**Water Supply Project Eastern and
Midlands Region**

Routing Report

Appendix E - Re-route Request Mapbook

Document no: 32105801/CPORoutingReport/AppendixE

Client		
Project	WATER SUPPLY PROJECT MIDLANDS AND EASTERN REGION	
Drawing Title	REROUTE MAPPING	
Drawing No.	32105801/300/00004	Drawing Status FOR REVIEW

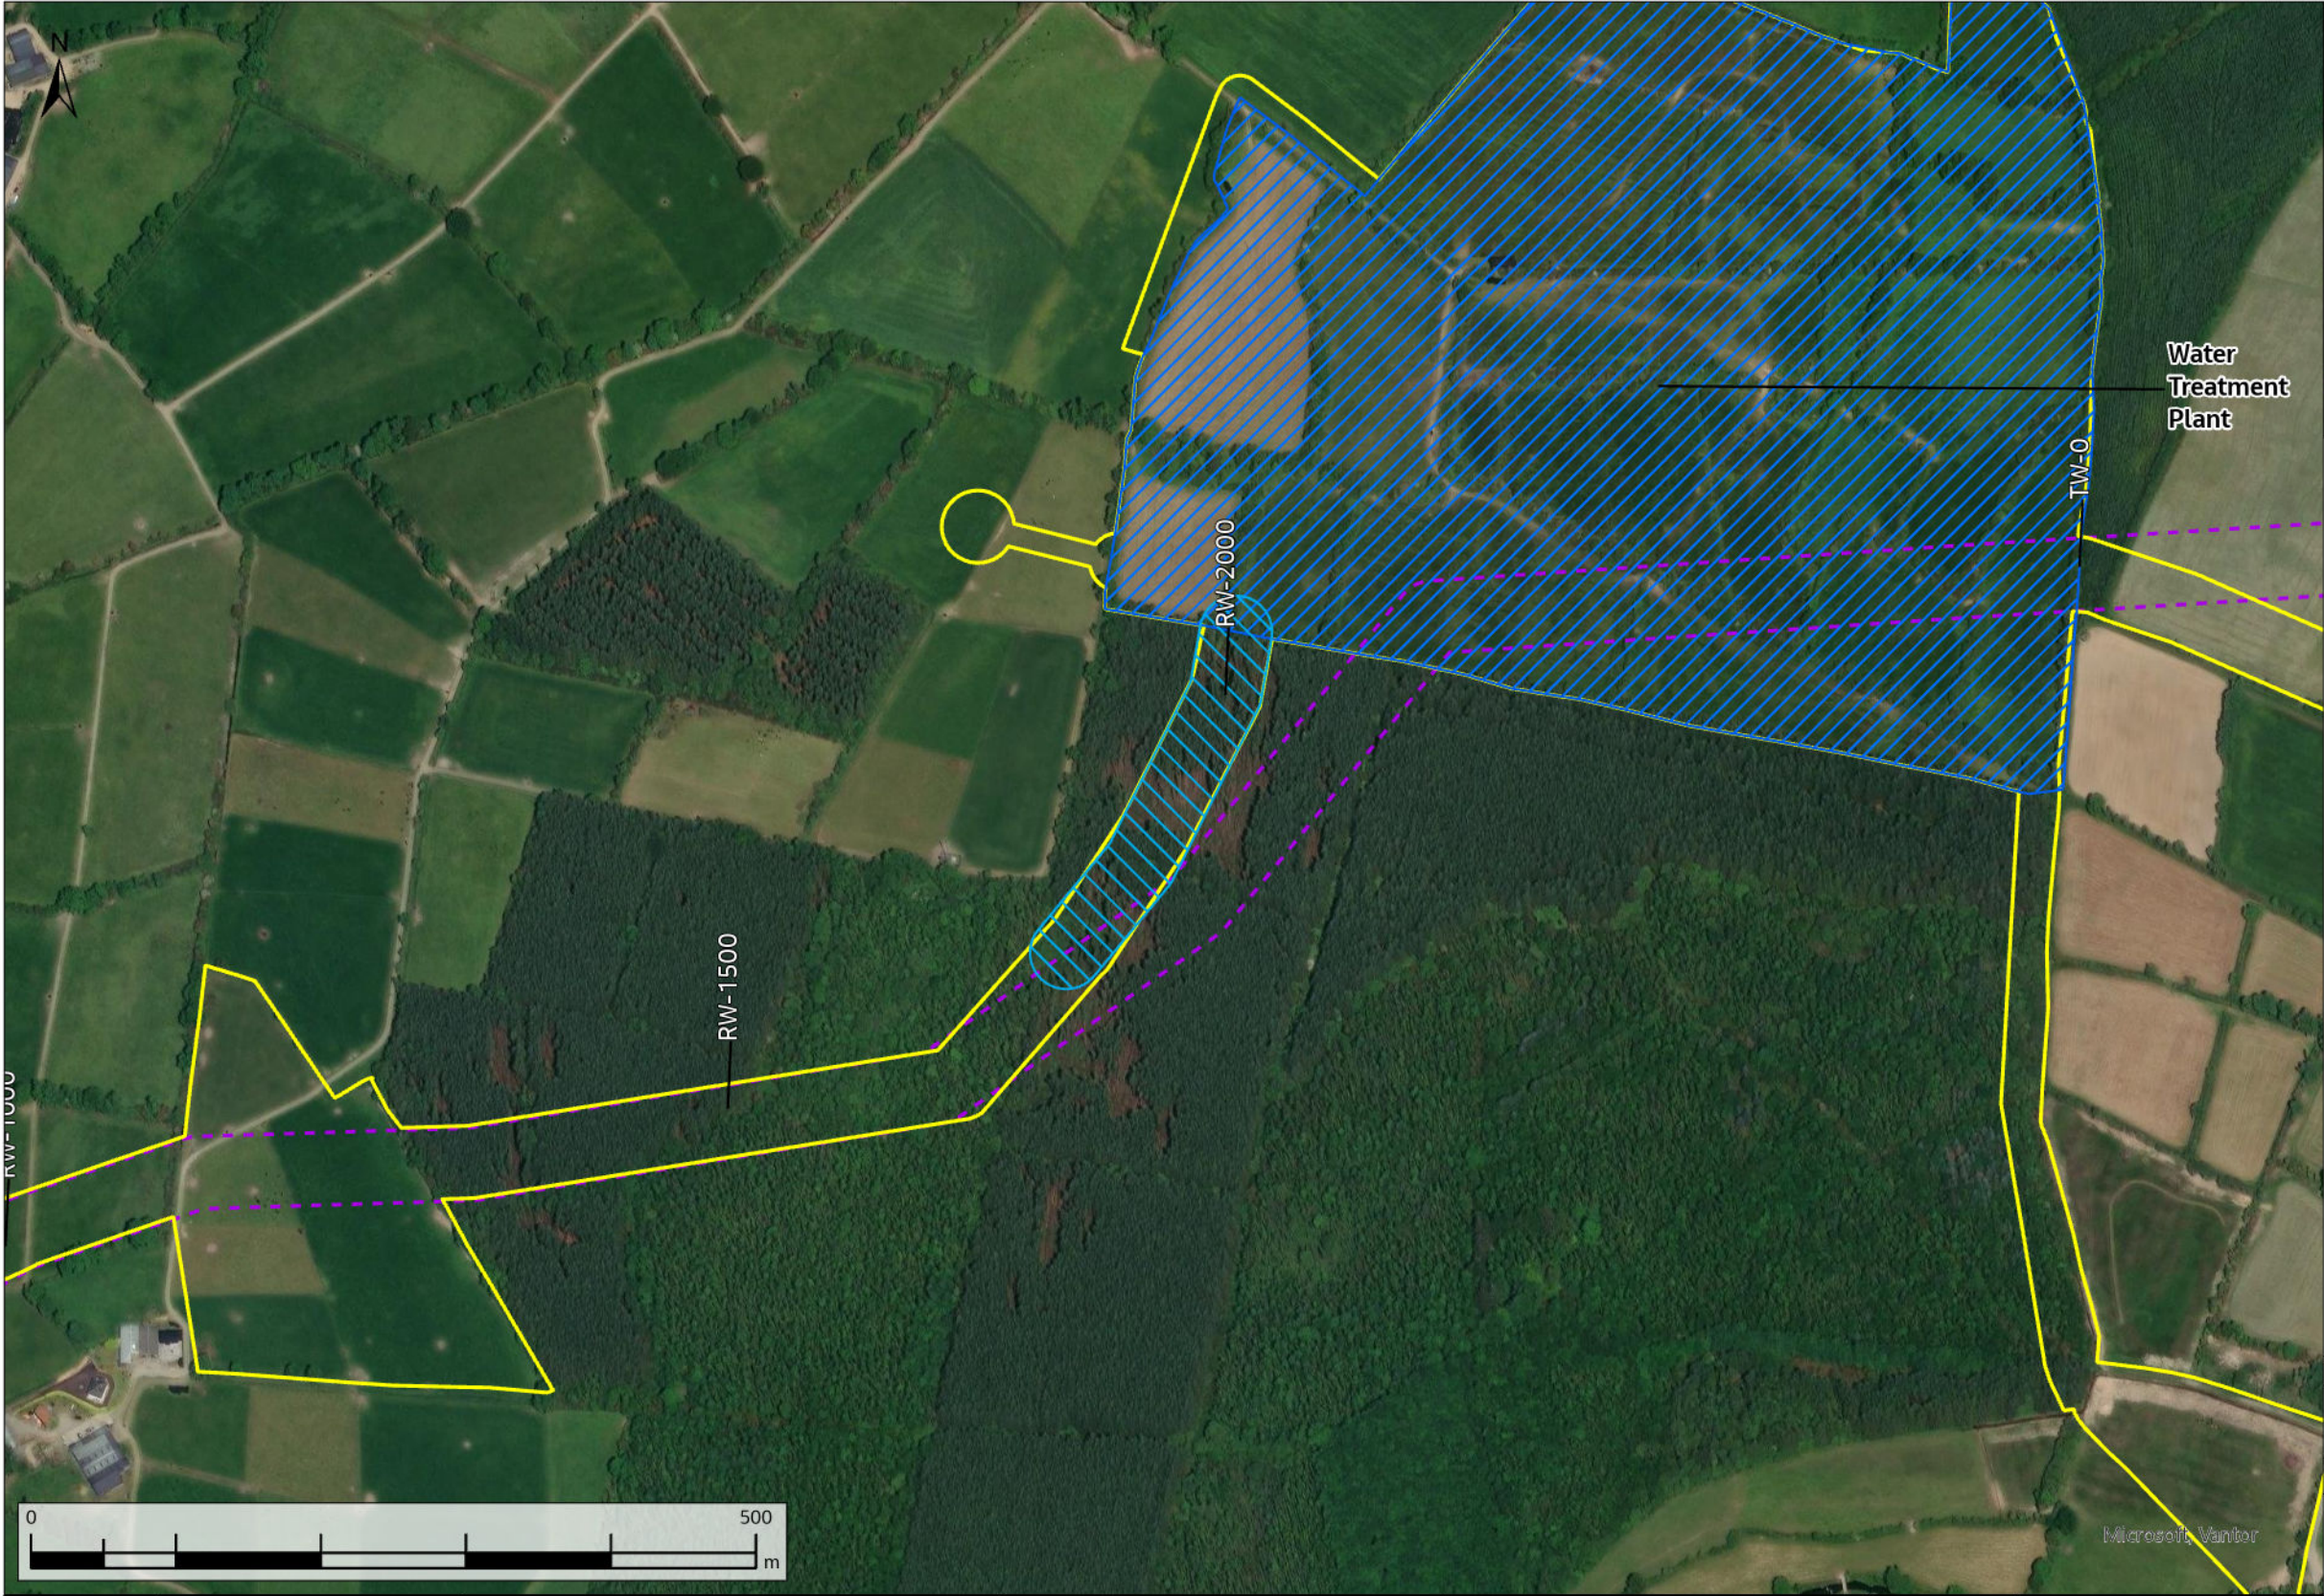
WAYLEAVE	QUERY SUMMARY	ENVIRONMENTAL ANALYSIS	TECHNICAL ANALYSIS	LANDOWNER ENGAGEMENT	DECISION	CLOSING COMMENTS
WL007	Technical Reroute Request - Alignment amendment to the west due to improved topography in order to facilitate construction works and pipeline approach to the water treatment plant from the west.	No environmental objection. Reroute would reduce impact on trees to the south of the water treatment plant. Mitigation measures could be required for badger setts within the reroute.	No technical objection.	Landowner has been made aware of the technical reroute.	Facilitated	Request has been facilitated.
RW-2000
